SUBJECT: Ink Cartridge Seal

FROM: Copier Technical Support Section

SS915/930/950

Transparent Seal

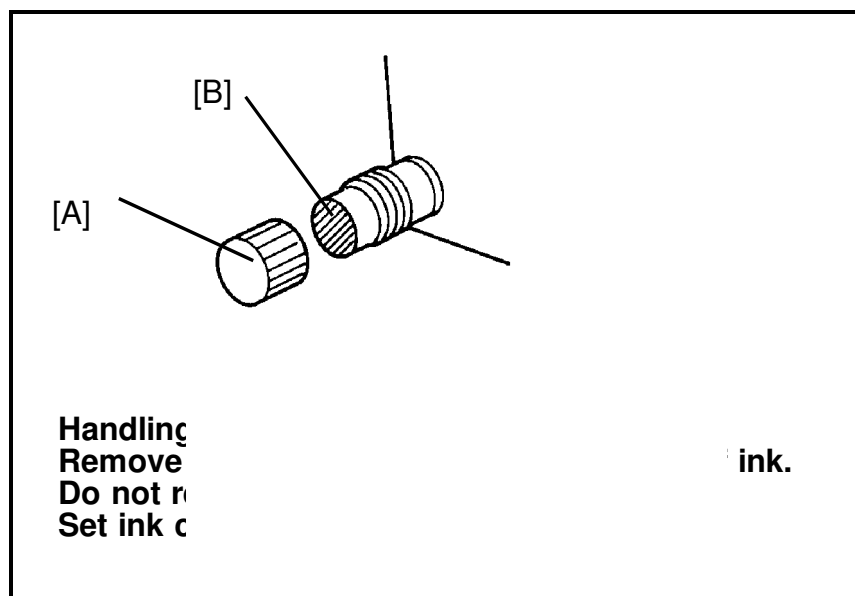
A transparent seal will be added to the exit of the ink cartridge (all colors) to prevent ink from being spilled on the floor during cartridge installation. It is not necessary to remove this seal; a projection on the ink pump inlet breaks this seal when the cartridge is set into the drum cartridge holder.

This modification will be implemented in the December production run. The following illustration and instructions will be printed on all ink cartridges early next year. This instructs the customers not to remove the seal at installation.

Installation Procedure for the Drum Blades Kit:

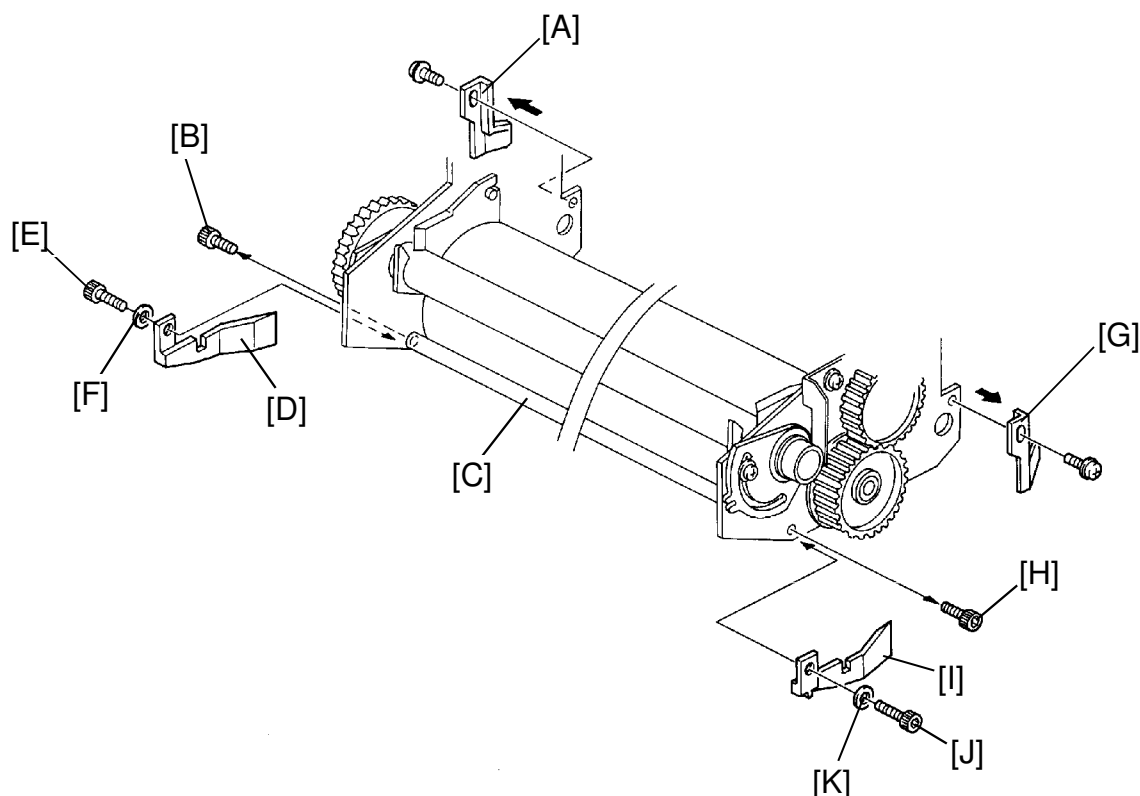
A drum blades kit has been registered as a spare part. With this retrofit kit, technicians can quickly and easily correct the drum ink leakage problem in the field.

1. Remove the drum clumper assembly.
2. Remove the tetron screens from the drum.
3. Remove the stainless steel screen from the drum.
4. Remove the old front drum blade (C2004745) [A] (1 screw).
5. Remove the internal hexagon head screw (M4 x 6) [B] securing the ink roller shaft stay [C], then install the new front drum blade (C2074745) [D] and secure it with the internal hexagon head screw (M4 x 8) [E] and the flat washer [F].
6. Remove the old rear drum blade (C2004746) [G] (1 screw).
7. Remove the internal hexagon head screw (M4 x 6) [H] securing the ink roller shaft stay [C], then install the new rear drum blade (C2074746) [I] and secure it with the internal hexagon head screw (M4 x 8) [J] and the flat washer [K].
8. Reverse the procedure to reassemble.

Note: Do not re-use the old front and rear drum blades.

Adjustment Procedure:

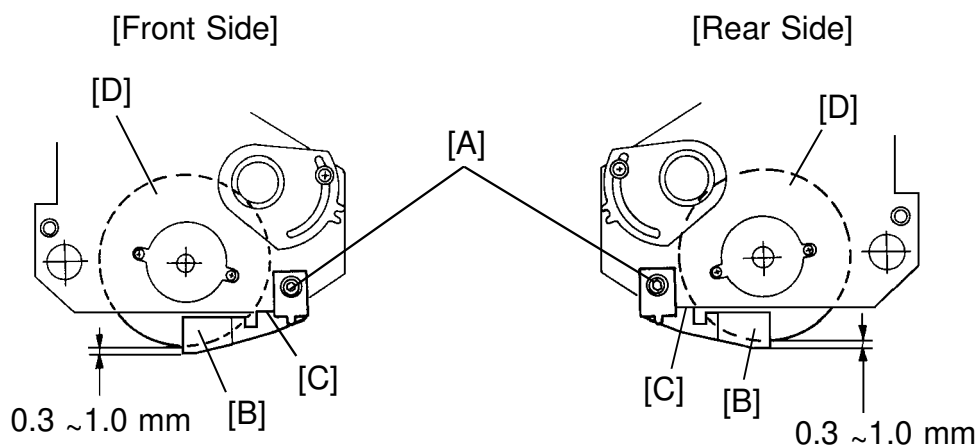
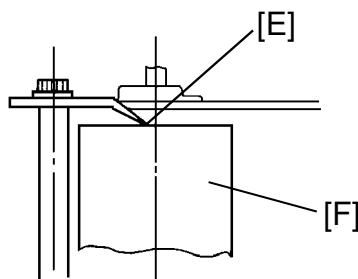
1. Tighten each (front and rear) internal hexagon head screw [A] so that the drum blade [B] contacts the lower edge [C] of the side plate.

Note 1: Make sure that the clearance between the ink roller [D] and the drum blade [B] is 0.3 to 1.0 mm.

Note 2: Make sure that the drum blade edge [E] contacts the ink roller [F].

SUBJECT: Thermal Head Cleaner Cap

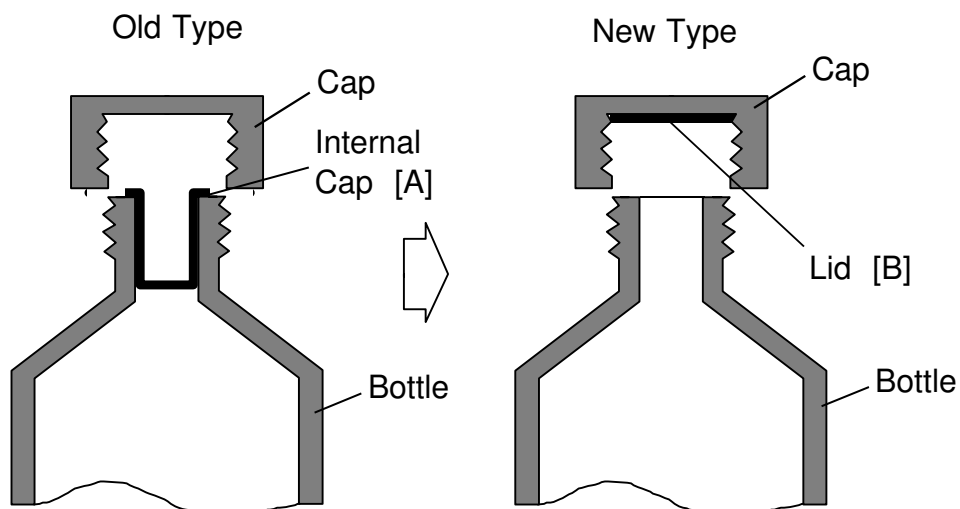
There has been a problem with the internal cap [A] getting stuck inside the thermal head cleaner bottle and it is difficult to pull it out.

The internal cap has been changed to a lid [B] as illustrated below:

This modification has been implemented since the November '90 production run. Please note that the part number of the thermal head cleaner remains the same.

SUBJECT: Separation Plate (P/N: 55076055)

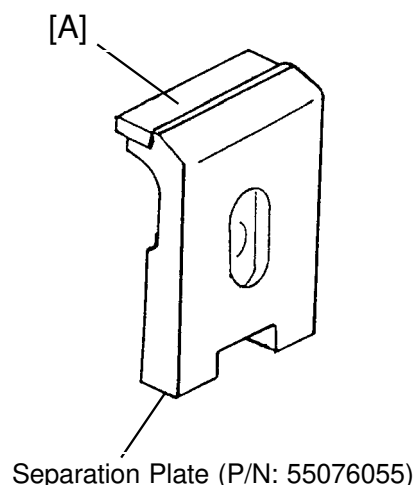
There have been reports in the field of the rubber separation pad [A] easily coming off the separation plate (P/N: 55076055) [B]. This occurred with separation plates that had been supplied as spare parts.

When installing a new separation plate, check the bond between the pad and the plate. If the bond is not sufficiently strong, apply a strong adhesive (super glue).

SUBJECT: Paper jams caused when one-way clutch slips

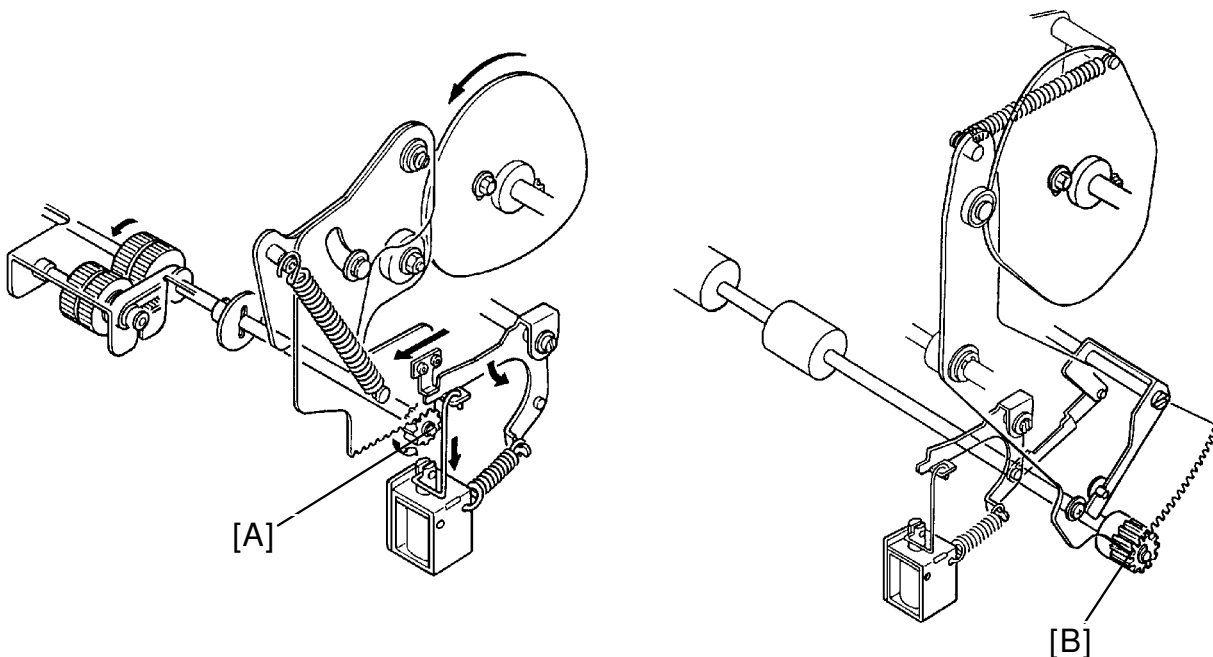
The one-way clutches inside the paper feed and second feed roller gears have worn the roller shafts smooth. The clutch slips and paper jams or is not fed. This tends to occur during high speed printing and is more likely to occur on machines that exceed the recommended monthly copy volume. When the feed mechanism is manually operated to check the paper feed, paper feeds correctly.

1. Remove the paper feed roller gear [A] and the second feed roller gear [B].
2. With fine sandpaper, lightly sand the roller shaft surface at the point where it comes into contact with the one-way clutch. This increases the coefficient of friction.
3. If paper jams continue to occur, replace the one-way clutch.
4. If paper jams continue to occur, replace the roller shaft together with the one-way clutch.

SUBJECT: Priport Ink Lot Number

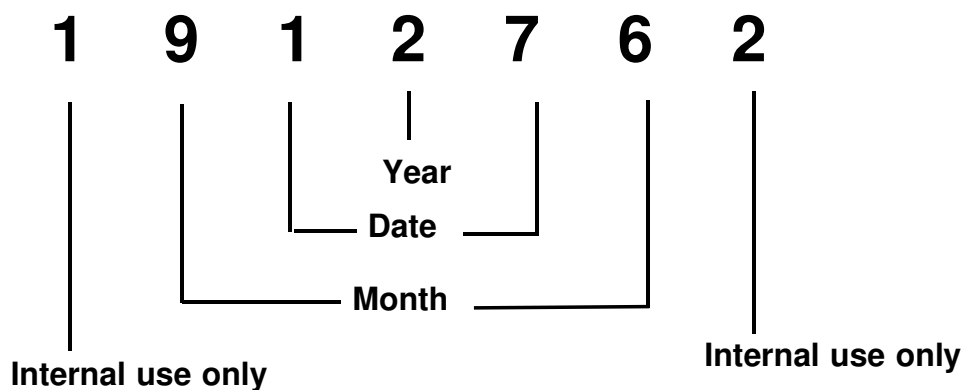
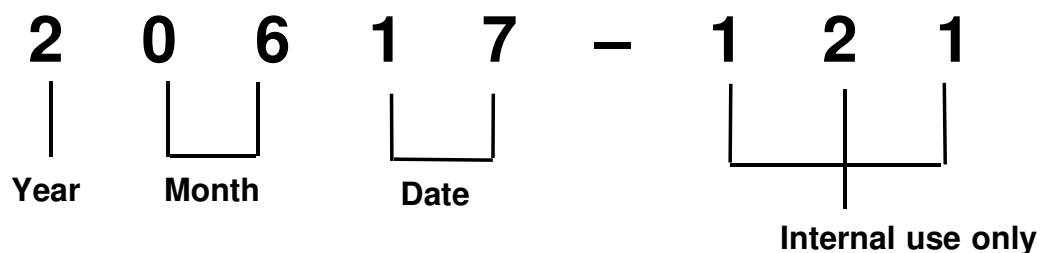
To clarify the ink production dating, the method of lot numbering has been changed as follows:

The above lot number means that the ink is produced on **June 17, '92**
